Moorebank Precinct West Stage 2

Noise and vibration independent review

Prepared for Department of Planning and Environment | 27 October 2017

Report J16215RP1 | Prepared for Department of Planning and Environment | 27 October 2017

Figure 5-1 Sensitive Receivers and Noise Monitoring Locations

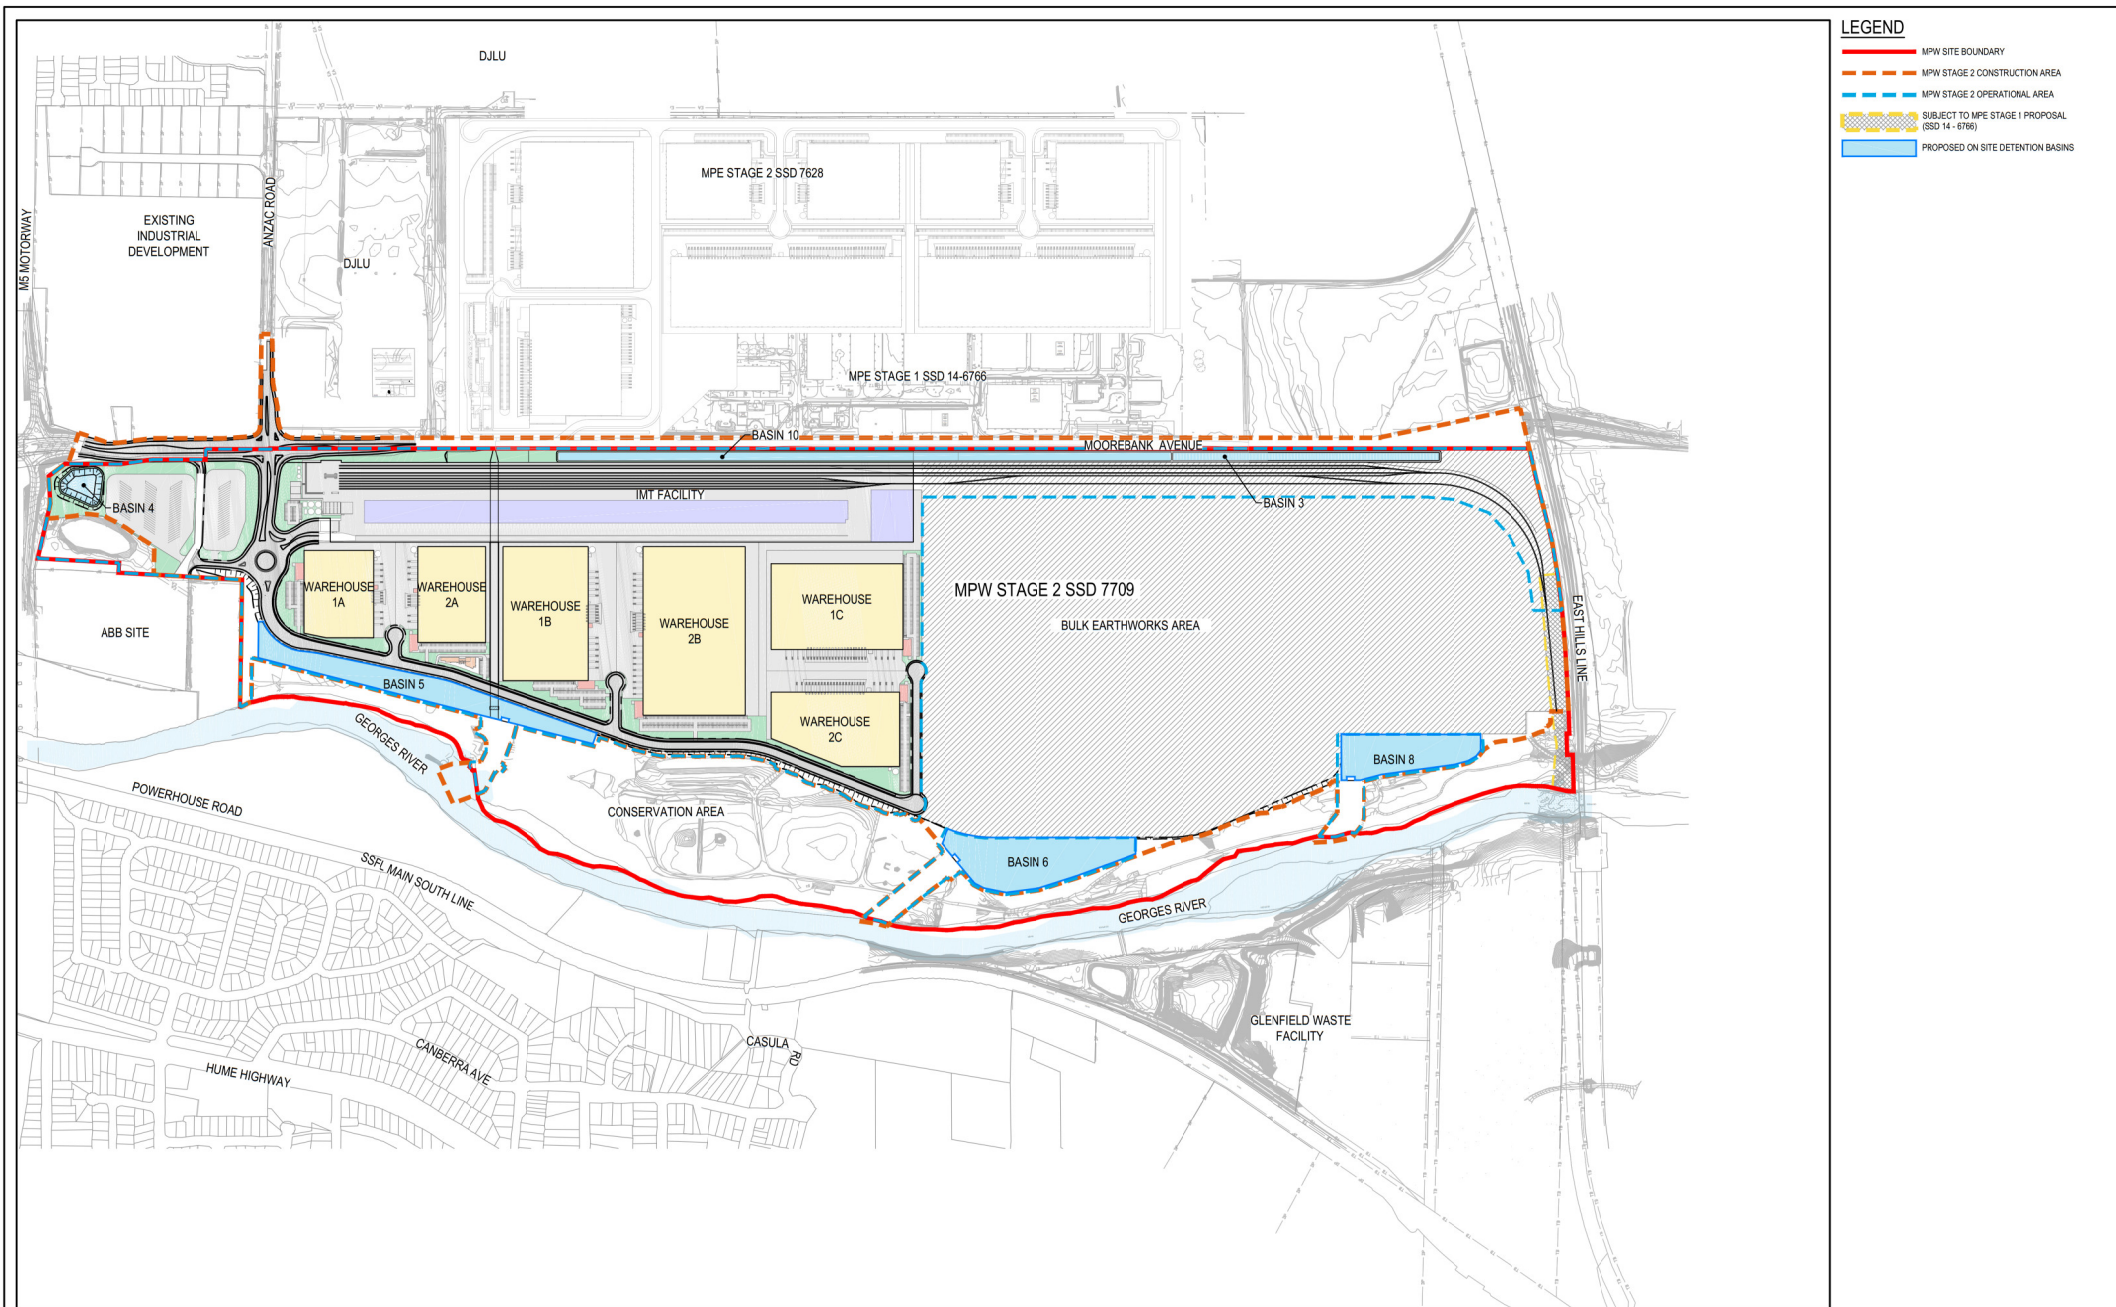
The noise assessment adopted three broad assessment areas surrounding the site as described above being Casula, Glenfield and Wattle Grove. The monitoring and assessment locations are shown in Figure 5.1 of the NVIA report which has been reproduced in Appendix B herein (Figure B.2).

The use of only one monitoring location for each of the relatively broad residential areas is identified as a limitation to the noise impact assessment. Normal practice is to include enough sampling spread across such large geographic areas to adequately represent the potentially most impacted locations.

The proponent's response to submissions includes an undertaking to continue ambient noise monitoring surveys within Casula, Wattle Grove and Glenfield.

This issue can be addressed through the draft recommendation conditions (eg to guide this further monitoring), should the DP&E grant approval.
